BID ADDENDUM NO. 3

Date of Addendum: April 10, 2026
Issued for Bid Date: March 27, 2026
Client Name: Public Schools of the Tarrytowns
Project Name: 2024 Capital Bond Project – Phase 2; Washington Irving Intermediate School
SED Project No.: 66-04-01-03-0-002-017
TUFSD Bid Number: 25/26-TUFSD-003
MEMASI Project No.: 101-2403
Contracts: Contract 1: General Construction (GC)
Contract 2: Mechanical Construction (MC)
Contract 3: Electrical Construction (EC)
Contract 4: Plumbing Construction (PC)

DOOR TYPES

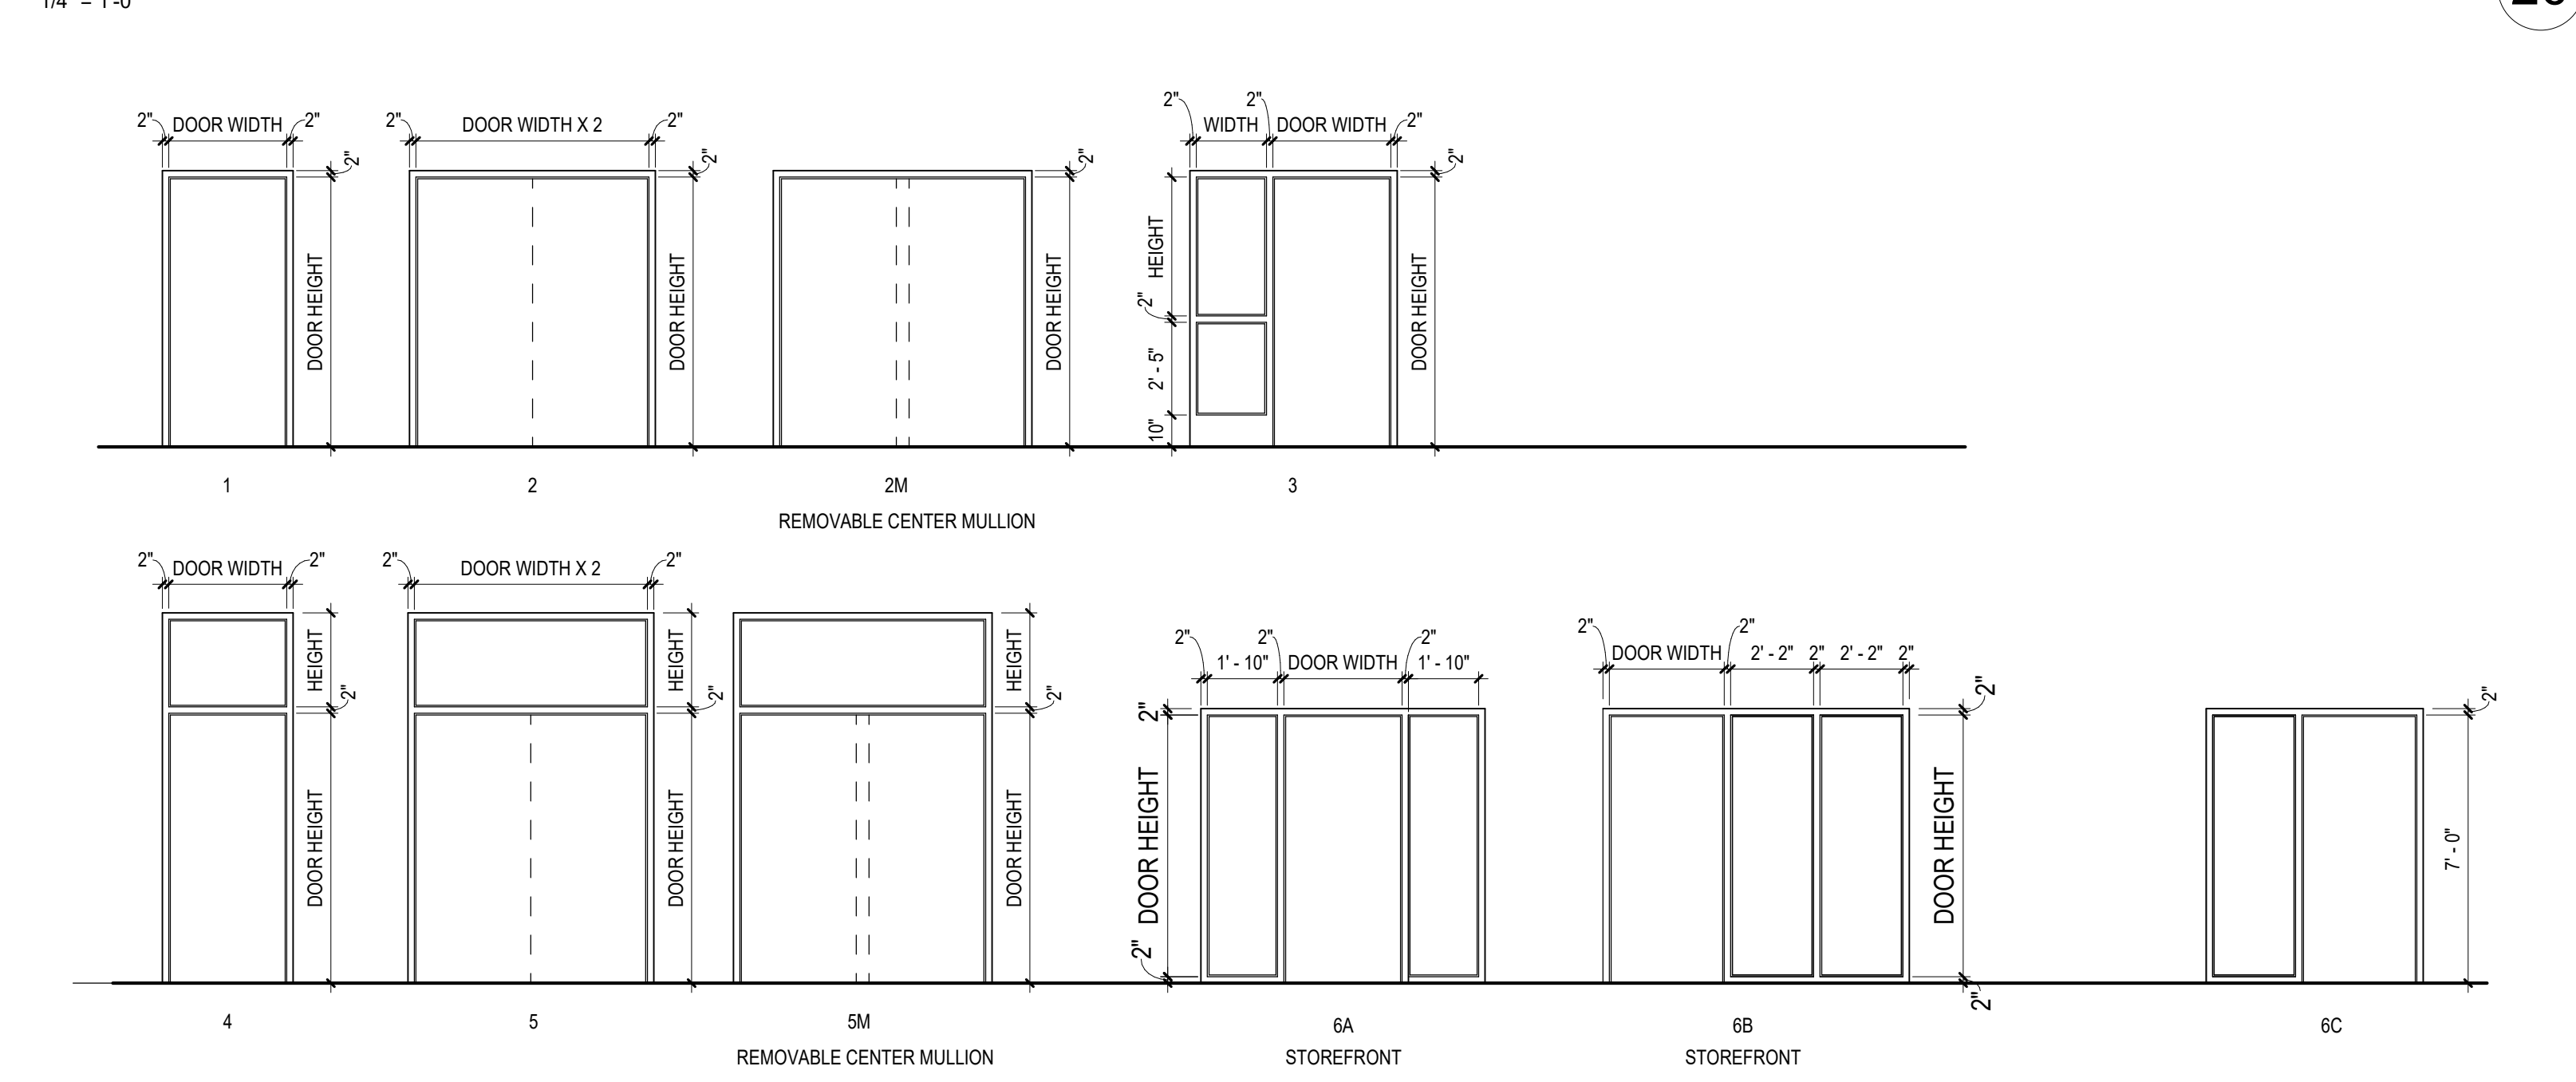
Response: There is not a separate Food Service Contractor.
- c. **Question:** Door type F1 on A610 calls for the louvers to be fusible link fire rated. Most of the doors are nonrated. Confirm standard fixed louvers are acceptable at nonrated locations.

Response: Provide standard fixed louvers in non-rated, Type F1 doors.
- d. **Question:** Louvers are not permitted in 20-minute doors. Do we omit the louver or the label at doors 005B-1, 005C-1, 005D-1, 005G-1, 205A-1 & 213-1?

Response: Maintain 20-minute fire rating and omit the louver at doors 005B-1, 005C-1, 005D-1, 005G-1, 205A-1 & 213-1.
- e. **Question:** Kindly confirm the material for door and frame #EXT-Q. The door schedule has an exterior wood door and hollow metal side-lite frame. There is no warranty on exterior wood doors.

Response: Door EXT-Q shall be an aluminum door with anodized finish within an aluminum curtain wall frame.
